2019 Project Review Sheet (2020 Construction)

| Project # | 19-249 |
| Project Title: | Add flashing beacons |
| Location: | Neighborhood: Ballard, 98107 Area: Crosswalk that crosses Shilshole Ave NW at NW Vernon Pl (Ballard) |

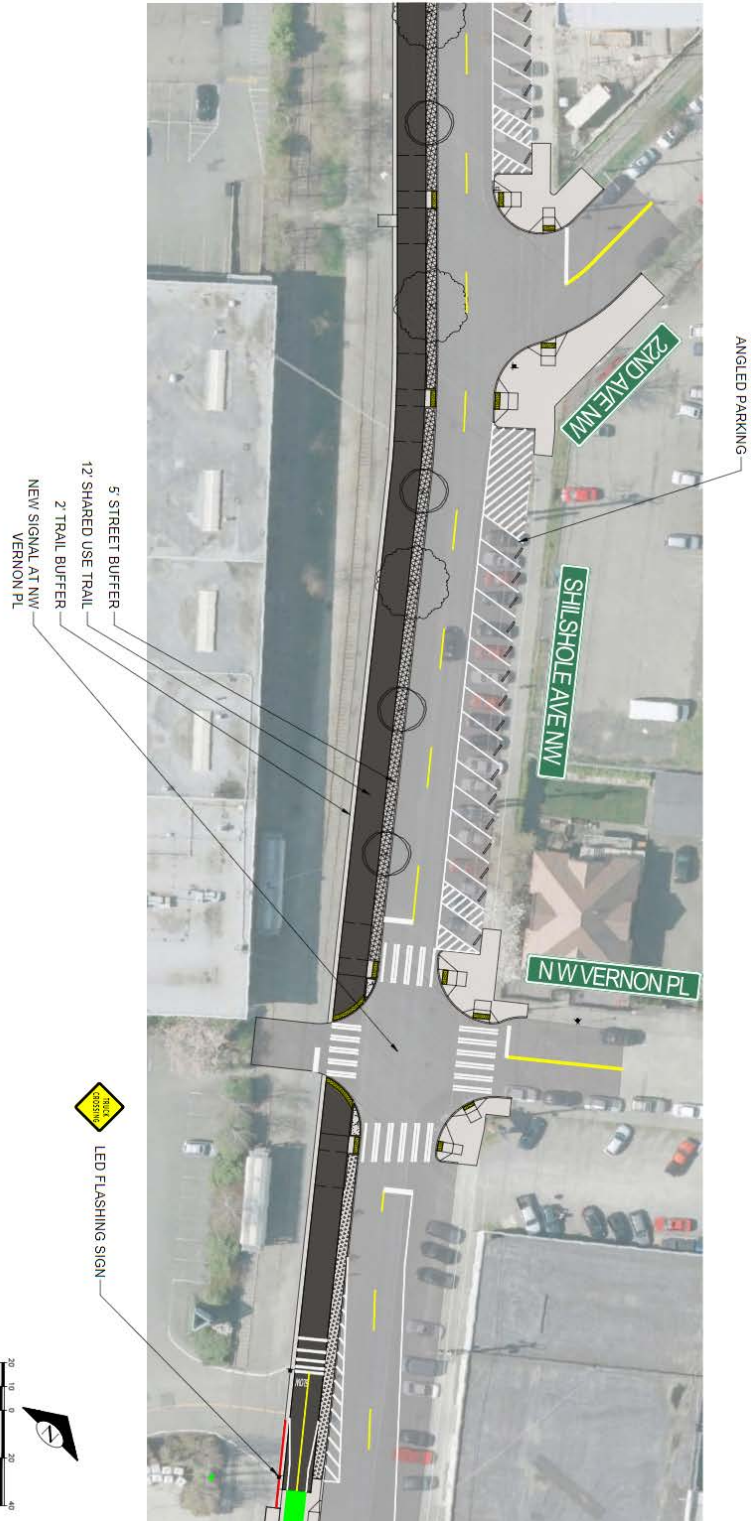
Comments: As part of the Ballard Multimodal Corridor Project where the missing link for the Burke-Gilman Trail will be constructed, this project will be adding a new signal at Shilshole Avenue NW and NW Vernon Place with ADA compliant curb ramps and connections to the new shared use trail with the existing sidewalks along NW Vernon Place and the east side of Shilshole Avenue NW. Construction is anticipated to start and completed sometime in the second half of 2020.

The Ballard Multimodal Corridor Project will be completing the Burke-Gilman Trail missing link and central portion of the project will follow Shilshole Avenue NW from Market Street to NW 45th Street. This section along Shilshole Avenue NW will construct a 12' wide shared use trail on the west side of Shilshole Avenue NW and will make intersection improvements including at NW Vernon Place. The improvements at this intersection include a new signal, accessible ADA compliant curb ramps and connection sidewalks to the existing sidewalk to the east of the intersection. This portion of the project is part of the Shilshole Phase and is anticipated to start in the second half of 2020 and completed at the end of 2020 or early 2021. More information on this project can be found at the projects website: <https://www.seattle.gov/transportation/projects-and-programs/programs/bike-program/ballard-multimodal-corridor>.
